[Docket No. FAA–2021–0189; Project Identifier AD–2020–00645–R; Amendment 39–21875; AD 2021–26–16]

Airworthiness Directives; Various Restricted Category Helicopters

ACTION: Final rule.

Figure 1 to the Introductory Text of Paragraph (g)(3) – Main Driveshaft Installation and Removal Tool

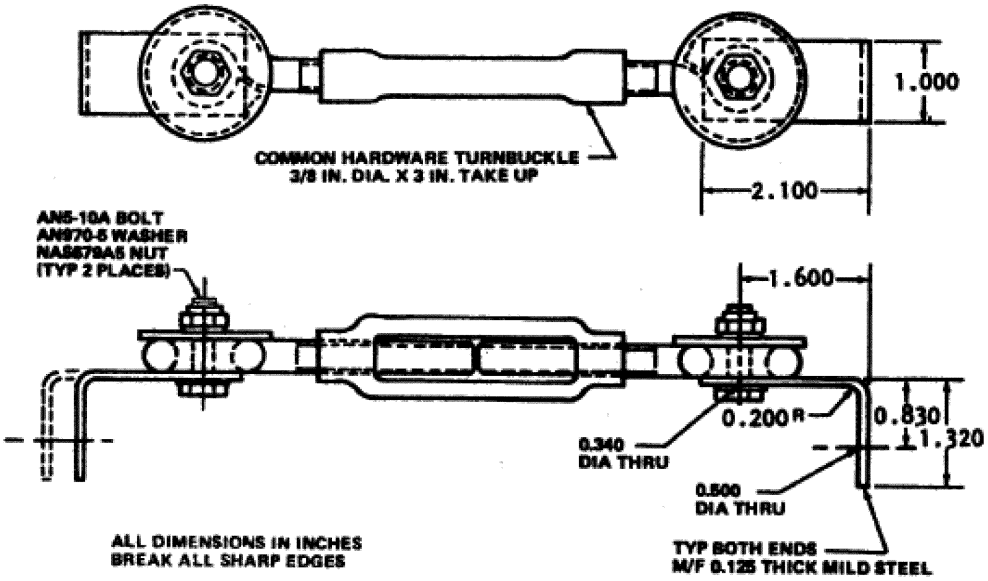
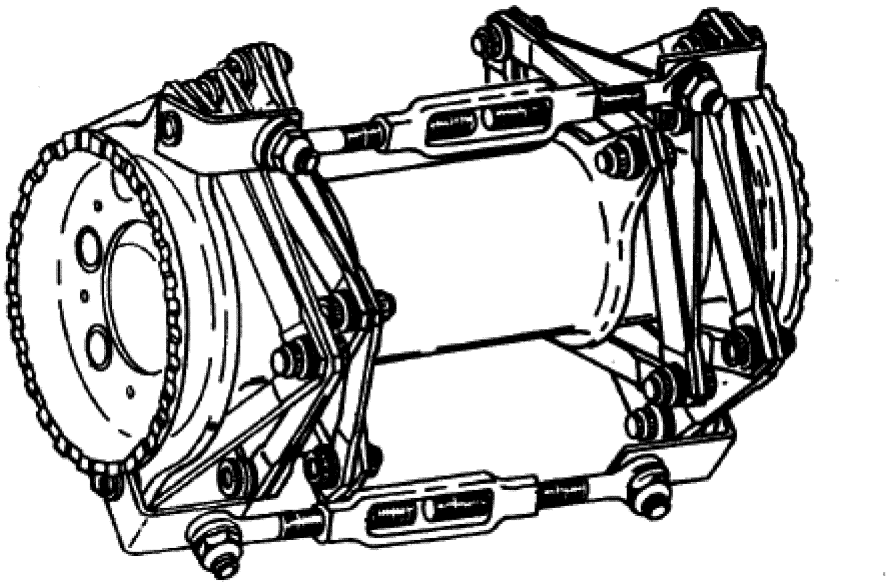
(3) Within 25 hours TIS after the effective date of this AD, remove main driveshaft P/N SKCP2180–1, SKCP2281–1, SKCP2281–1R, or SKCP2281–103 by following ''6–24.3. Removal—Main Driveshaft P/N SKCP2281–103'' on page 6–24, including ''4–24. Removal—Air Inlet Filters'' on page 4–17 and ''Figure 4–9. Engine Air Inlet Filter Installation'' on page 4–16, of Headquarters, Department of the Army, Aviation Unit and Intermediate Maintenance Instructions Army Model UH–1H/V/EH–1H/X Helicopters, Technical Manual TM 55–1520–210–23–1, Change No. 42, dated April 14, 2003 (TM 55–1520–210–23–1 C 42), except where instructed to ''refer to figure 6–12.2'' in TM 55–1520–210–23–1 C 42, refer to Figure 1 to the introductory text of paragraph (g)(3) of this AD, and where instructed to ''see figure 6–12.3'' in TM 55–1520–210–23–1 C 42, see Figure 2 to the introductory text of paragraph (g)(3) of this AD, and:

Note 3 to the introductory text of paragraph (g)(3): Figures 6–12.2 and 6–12.3 are missing from TM 55–1520–210–23–1 C 42.

Figure 3 to Paragraph (g)(3)(iv) – Damage Limits

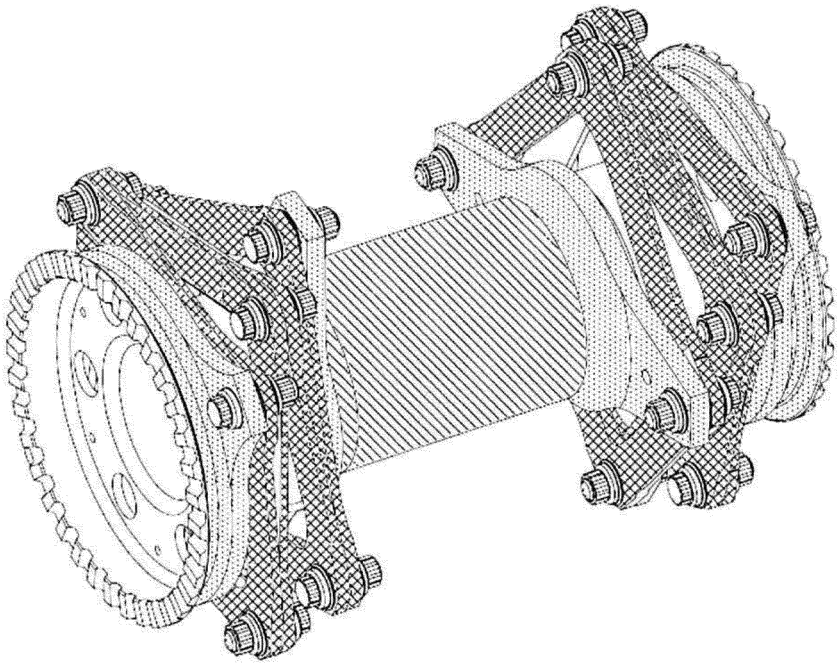
(iv) Inspect the main driveshaft for mechanical damage, corrosion, an edge dent, and nick as shown in Figure 3 to paragraph (g)(3)(iv) of this AD. For the purposes of this inspection, mechanical damage may be indicated by a crack, scratch, or wear; and corrosion may be indicated by corrosion or pitting. If there is a scratch, wear, corrosion, pitting, an edge dent, or a nick within allowable limits, before further flight, repair the main driveshaft in accordance with FAA-approved procedures. If there is a crack, or a scratch, wear, corrosion, pitting, an edge dent, or a nick that exceeds allowable limits,

before further flight, replace the main driveshaft. The main drive shaft may be overhauled in accordance with FAA-approved procedures to accomplish the replacement required by this paragraph.
